Differences Between MSP430F67xx and MSP430F67xxA Devices

ABSTRACT

This application report describes the enhancements of the MSP430F67xxA devices from the non-A MSP430F67xx devices. In the course of this application report, the MSP430F67xx errata that are fixed in the MSP430F67xxA and the additional features added to the MSP430F67xxA devices are discussed. In addition, metrology results are compared to further show that the changes implemented in the MSP430F67xxA devices do not affect the metrology performance.

Figure 3. EVM430-F6779 Performance With MSP430F67791

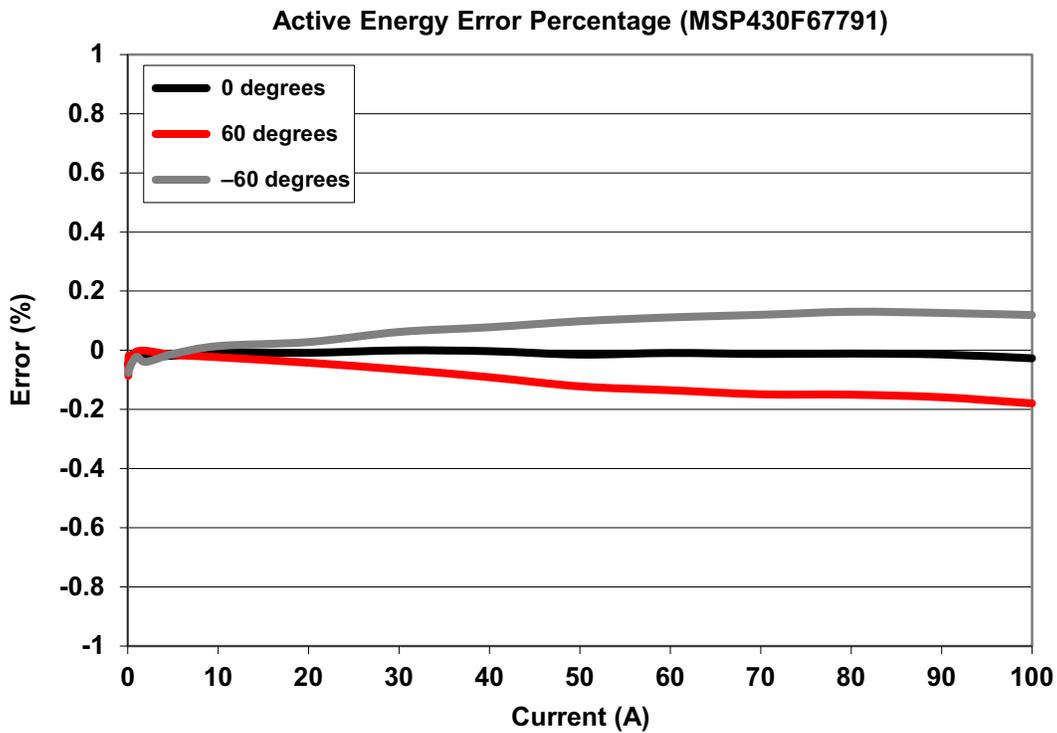
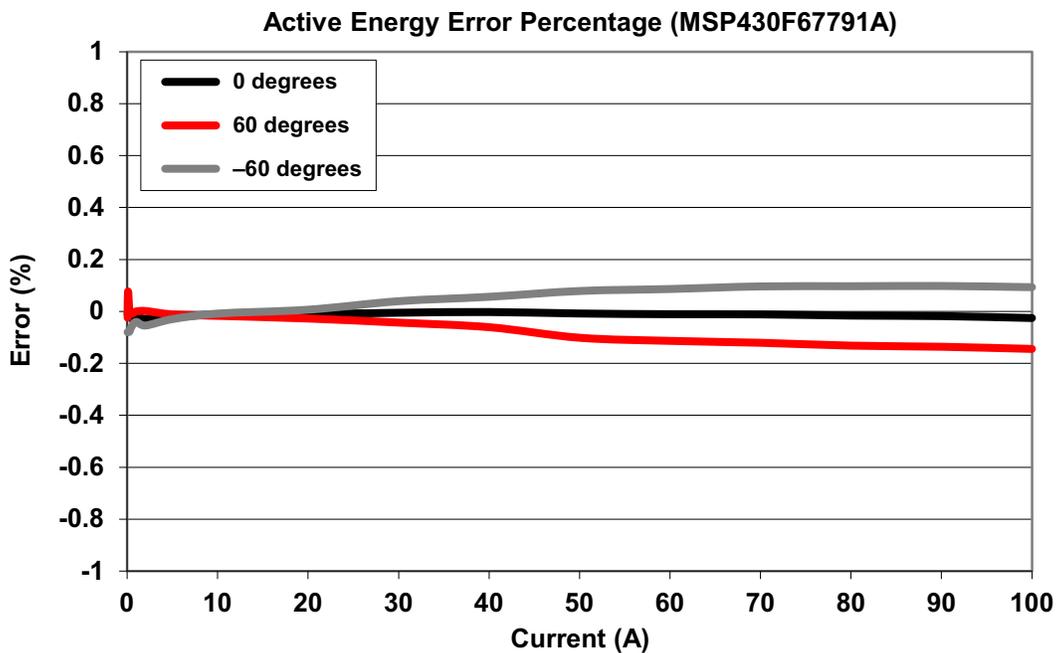
[Table 6](#), [Figure 3](#), and [Figure 4](#) show the metrology results for the MSP430F67791 and MSP430F67791A. [Table 7](#), [Figure 5](#), and [Figure 6](#) show the metrology results for the MSP430F6736 and MSP430F6736A. In both sets of results, the A version of the chips do not differ significantly from the non-A versions of the chips.
